Testing the Feasibility of Multi-Modular Design in an HTR-PM Nuclear Plant

Parts of this Peer Review File have been redacted as indicated to remove third-party material.

This file contains all reviewer reports in order by version, followed by all author rebuttals in order by version.

Fig. I. Composition of the coordinated control system of HTR-PM plant

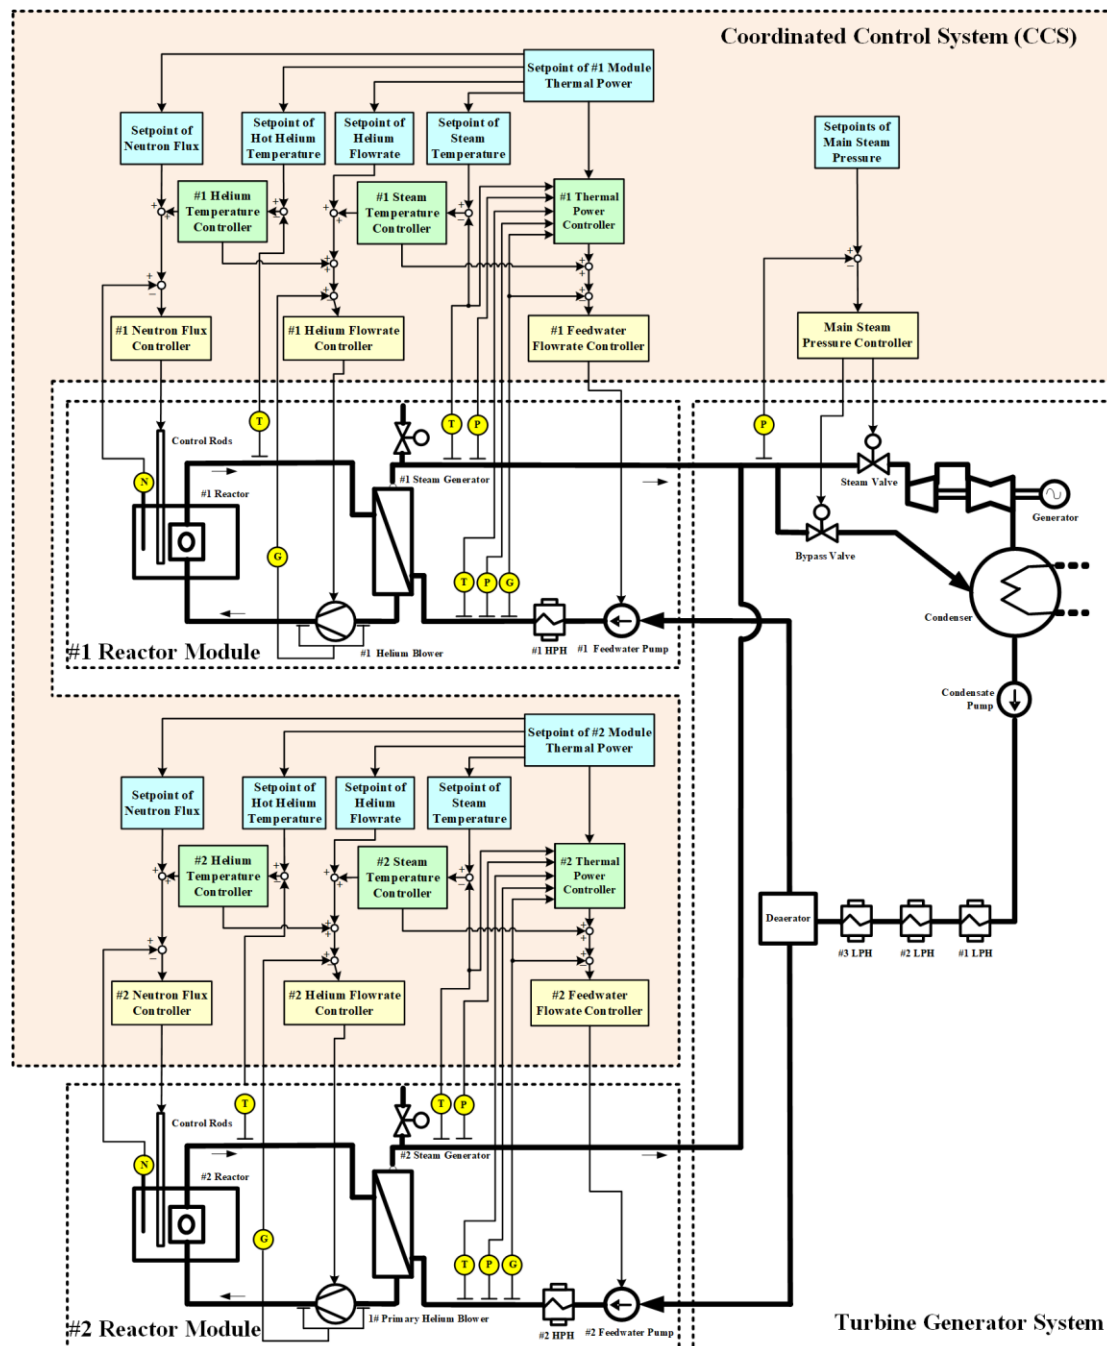
Fig. 3: Are the sensors of Reactor Module #2 connected to a separate CCS or to the same as for #1? If they are separate, how do the two CCS talk to each other? Is there a redundancy of sensors and if so, do you use e.g. a 2 out of 3 logic in the CCS to avoid unnecessary reactor scrams? What is the physical shape of the CCS? Is it a Programmable Logic Controller (PLC)? Please explain more about its capabilities and whether it is redundant (e.g. like on airplanes). The CCS seems to be an active component ensuring the operability and to some extent the safety of the multi-module plant. Have you analyzed what will happen if the CCS itself malfunctions? Have you analyzed the reaction of the CCS in case of component failure (e.g. assuming a pump seizure)? What are the requirements on the CCS imposed by the nuclear regulator?

Comment 6: Fig. 3: Are the sensors of Reactor Module #2 connected to a separate CCS or to the same as for #1? If they are separate, how do the two CCS talk to each other? Is there a redundancy of sensors and if so, do you use e.g. a 2 out of 3 logic in the CCS to avoid unnecessary reactor scrams? What is the physical shape of the CCS? Is it a Programmable Logic Controller (PLC)? Please explain more about its capabilities and whether it is redundant (e.g. like on airplanes).

Response: Thanks deeply for the insightful comment about the CCS. Focusing on the test results, the introduction to the CCS design and its implementation is given briefly in the original manuscript. According to this comment, to emphasize the individual control between two reactor modules, Fig.3 is modified and shown as the following Fig. 1. From Fig. 1, the sensors of reactor module

#2 are connected an individual coordinated control subsystem composed by (1) neutron flux controller, (2) helium controller, (3) feedwater flowrate controller, (4) helium temperature controller, (5) steam temperature controller and (6) thermal power controller like that of #1 module. Actually, each reactor module is equipped with these six controllers individually, giving the coordination amongst multiple process variables belonging a single reactor module. From Fig. 1, it can be seen that the two reactor modules provide superheated steam of the same parameter to a common turbine-generator system, and the coordination between two reactor modules is given by the main steam pressure control stabilizing the common steam pressure at the inlet of the steam turbine. For the coordination between modules, it is also necessary to stabilize the steam temperatures at the secondary outlets of steam generators by the individually equipped steam temperature controllers.

In addition, there are redundancy of sensors for measuring process variables. From Fig. 3, it can be seen that the measurements of process variables, including the reactor neutron flux, helium flowrate, feedwater flowrate, steam temperature as well as steam pressure at the OTSG secondary outlet, feedwater temperature as well as feedwater pressure at the OTSG secondary inlet, and main steam pressure at the turbine inlet are all input signals of the CCS. For each process variable inputted to the CCS, three or even four redundant sensors are equipped for the measurement of the process variable. For the process variables with 3 redundant sensors, 2 out of 3 logic is adopted to avoid unnecessary reactor scrams. For the process variables with 4 redundant sensors, 3 out of 4 logic is adopted.

In the revised manuscript, Fig. 3 is modified as Fig. I to illustrate that those six controllers are equipped to each reactor module individually. The discussion on sensor redundancy and the physical shape of CCS are all added to the newly given section 2.1 in the revised manuscript, and the following Fig. II has also been added to the revised manuscript as Fig. 4.
